Access Compliance Report

Public Rights-of-Way

Intersection ID: 31738	Main Street: LEAF_PLUM_DR	Cross Street: SAWLEAF_CT	Location: NE
ADA ID: 89605C2406EF	Ramp Type: PerpDiag	Initial Pass/Fail: Fail	Overall Compliance: No
		Severity Score: 12.5

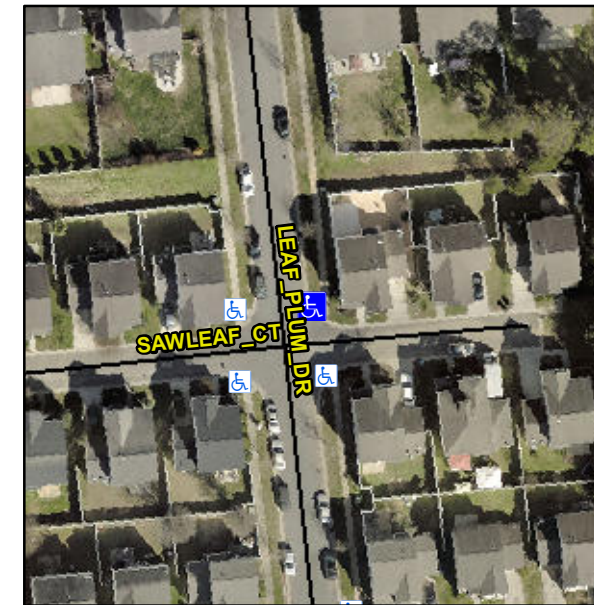
Not Found, R304.2.2

Compliance	Description	Data	Compliance	Description	Data
N/A	Ramp Length (in)	55.5	No	Ramp Slope (%)	9.7
Yes	Ramp Width (in)	48.0	Yes	Ramp XSlope (%)	1.6
N/A	Flare Type LT	N/A	N/A	Flare Type RT	N/A
N/A	Flare Slope LT (%)	N/A	N/A	Flare Slope RT (%)	N/A
N/A	Flare Traversable LT?	N/A	N/A	Flare Traversable RT?	N/A
N/A	Landing Length (in)	N/A	N/A	DWS Provided?	N/A
N/A	Landing Width (in)	N/A	N/A	DWS Contrast?	N/A
N/A	Landing Slope (%)	N/A	N/A	DWS Length (in)	N/A
N/A	Landing X Slope (%)	N/A	N/A	DWS Full Width?	N/A
N/A	Landing Curb? (Y/N)	N/A	N/A	DWS Offset (in)	N/A
N/A	Shared Landing?	N/A			
N/A	Gutter Ponding?	N/A	N/A	Gutter Slope (%)	N/A
N/A	Gutter Lip Ht (in)	N/A	N/A	Gutter X Slope (%)	N/A
N/A	Painted X Walk1?	No	N/A	Painted X Walk2?	No
	X Walk 1 Direction	To W		X Walk 2 Direction	To S
N/A	X Walk 1 Width (in)	N/A	N/A	X Walk 2 Width (in)	N/A
	X Walk 1 Slope (%)	1.1		X Walk 2 Slope (%)	0.9
	X Walk 1 X Slope (%)	2.2		X Walk 2 X Slope (%)	3.9

Remove & Replace Curb Ramp With Two New Directional Ramps or Equivalent.
